STATE OF NORTH CAROLINA
DEPARTMENT OF TRANSPORTATION

Subject: **Request for Permit Modification** for TIP No. U-2404 A, Catawba
County, Newton/Conover Loop; State Project No. 8.1792401; Federal Aid
Project No. MA-STP-16(2), Division 12.

Reference: Individual Permit, USACE Action ID No. 200331233, issued on
December 4, 2003. Major Certification, DWQ Project No. 031048, issued
on October 8, 2003.

The U.S. Army Corps of Engineers (USACE) issued a Section 404 Individual Permit (IP) to the North Carolina Department of Transportation (NCDOT) on December 4, 2003 for construction of the Newton-Conover Eastern Loop, from NC Highway 16 north to SR 1739 (Emanuel Church Road) east of Newton, Catawba County. The purpose of this letter is to request a modification of Permit Site Nos. 1, 3, & 5.

Permit Site #3
 Red Cross Lane installed @ inlet pipe

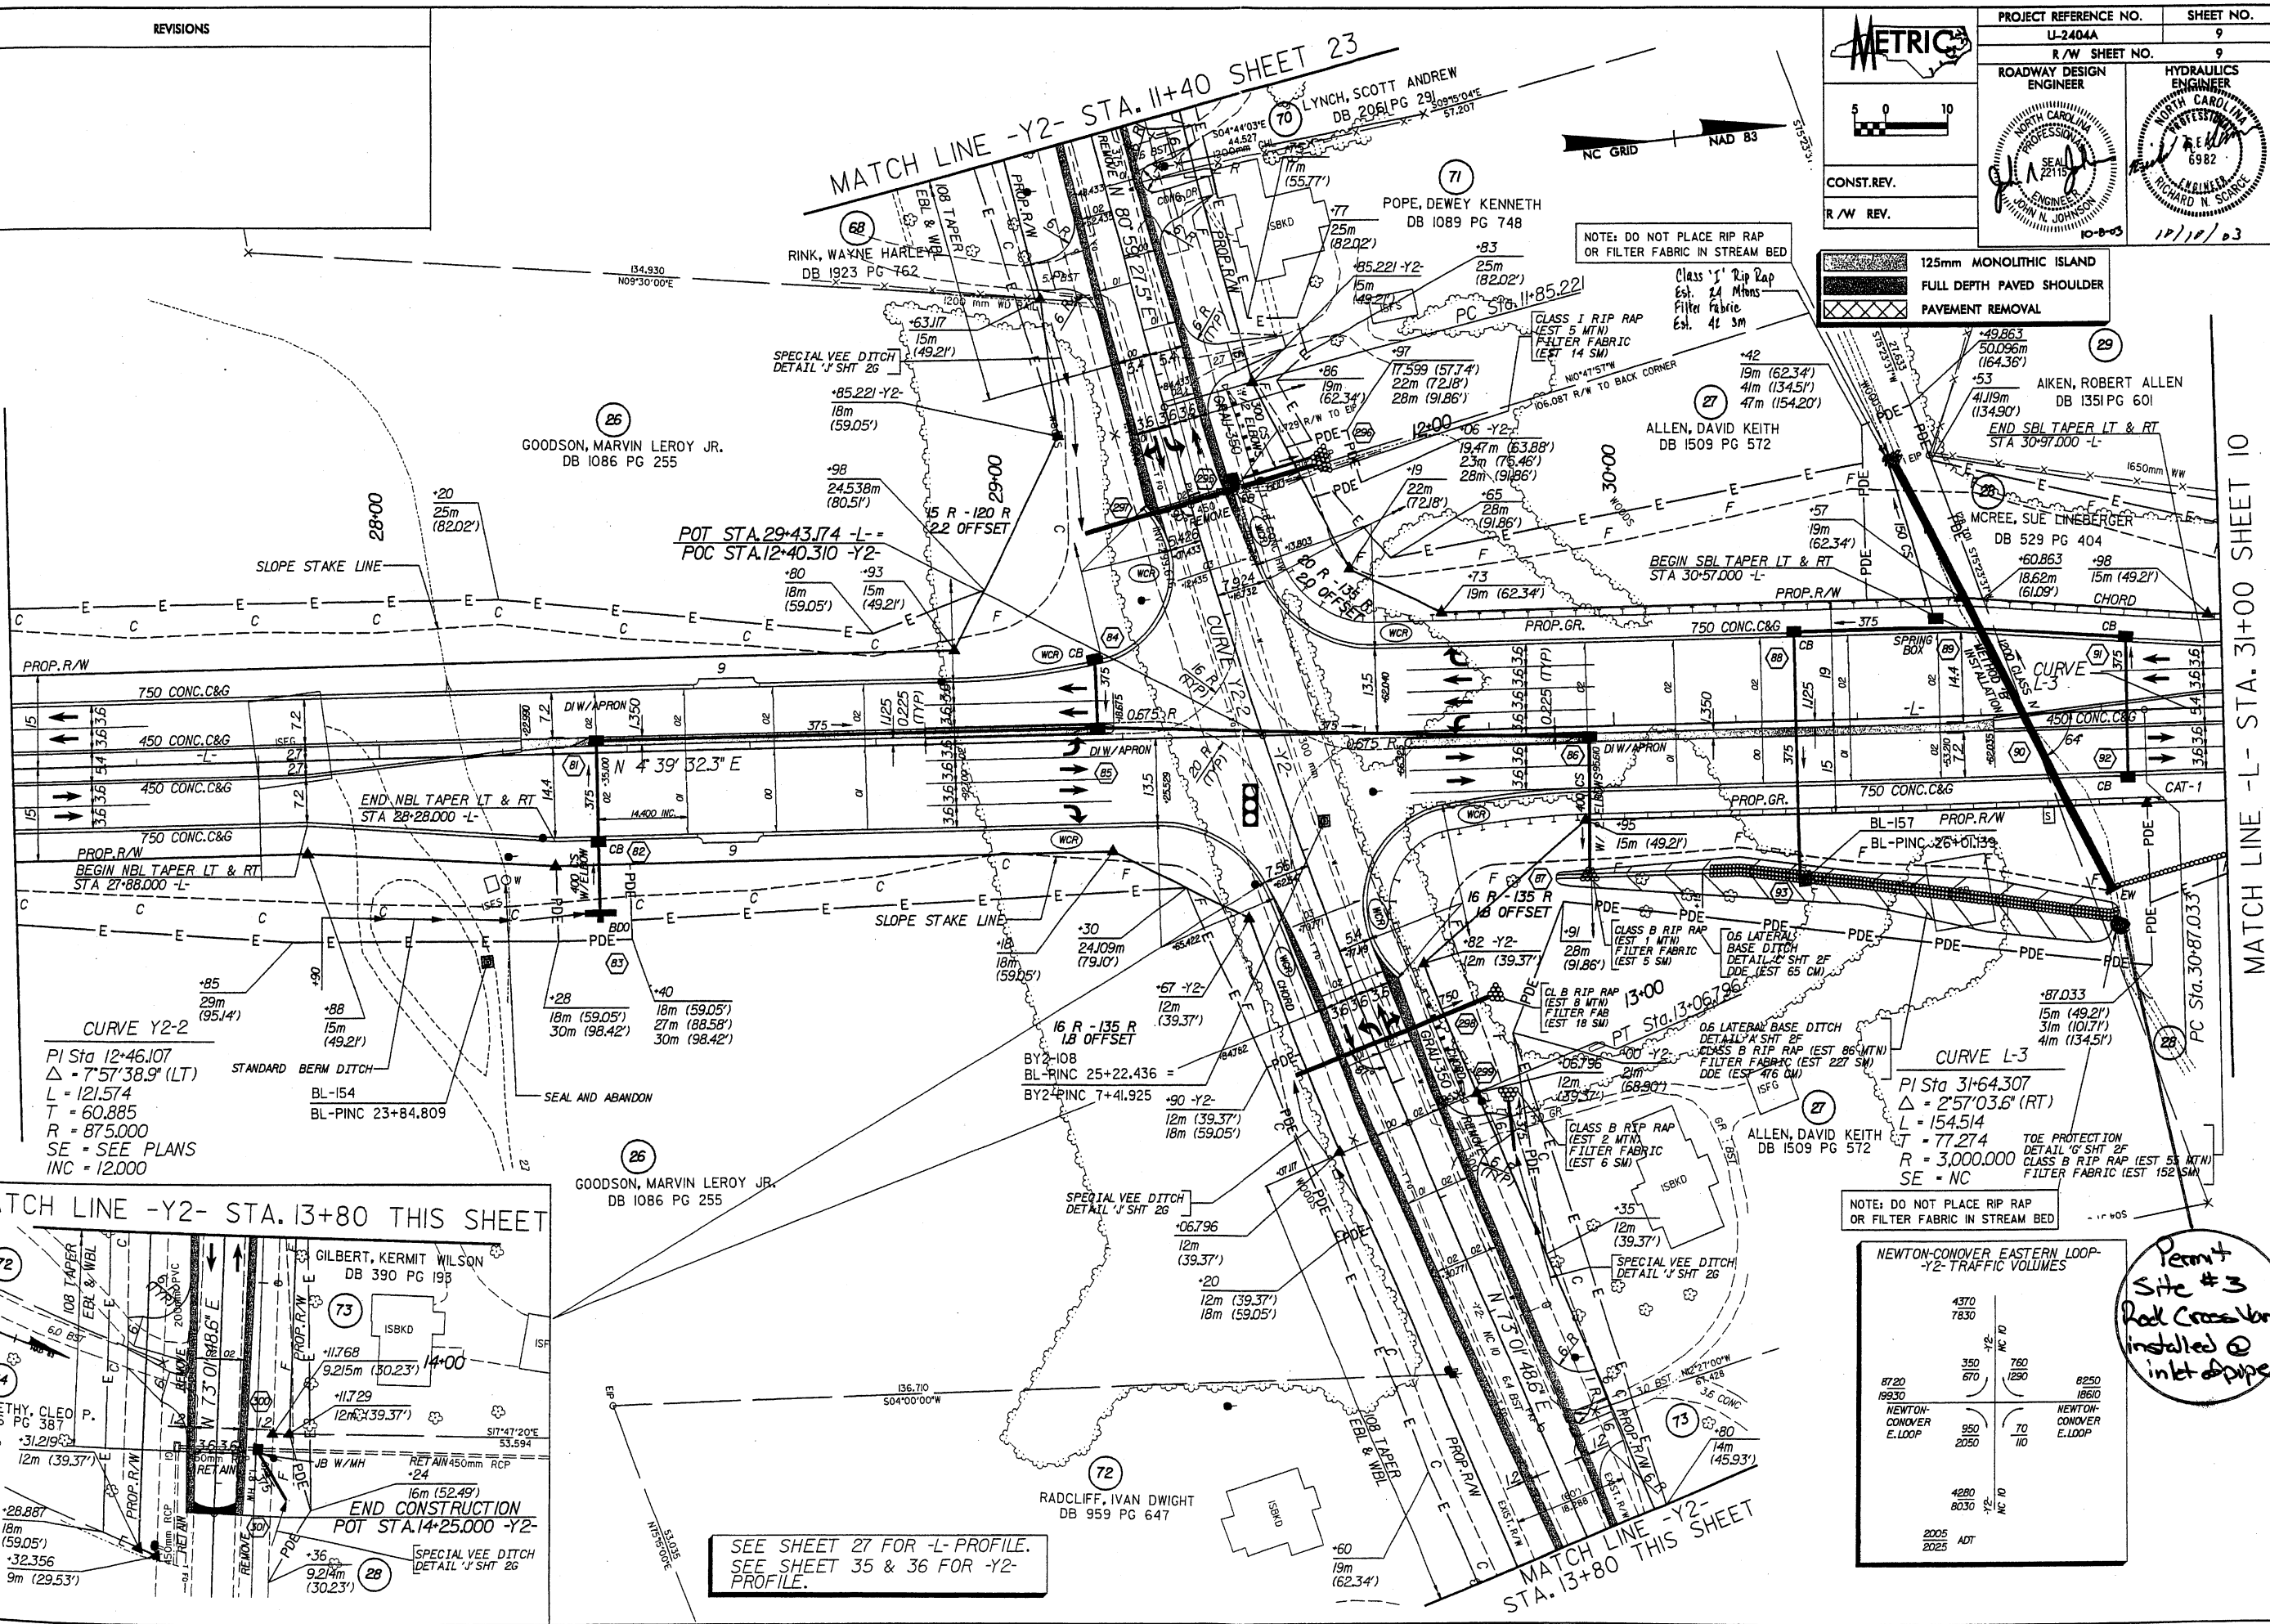
At Permit Site No. 3 rip-rap has fallen into the stream from the adjacent rip-rap lined ditch located at the inlet end of the culvert. Also, the bank of the stream has sloughed off and deposited sediment into the stream. As a result, there is a large head-cut forming upstream. We plan to remove the rip-rap and sediment from the stream, stabilize the sloughed bank, and install a cross vane to prevent further damage.
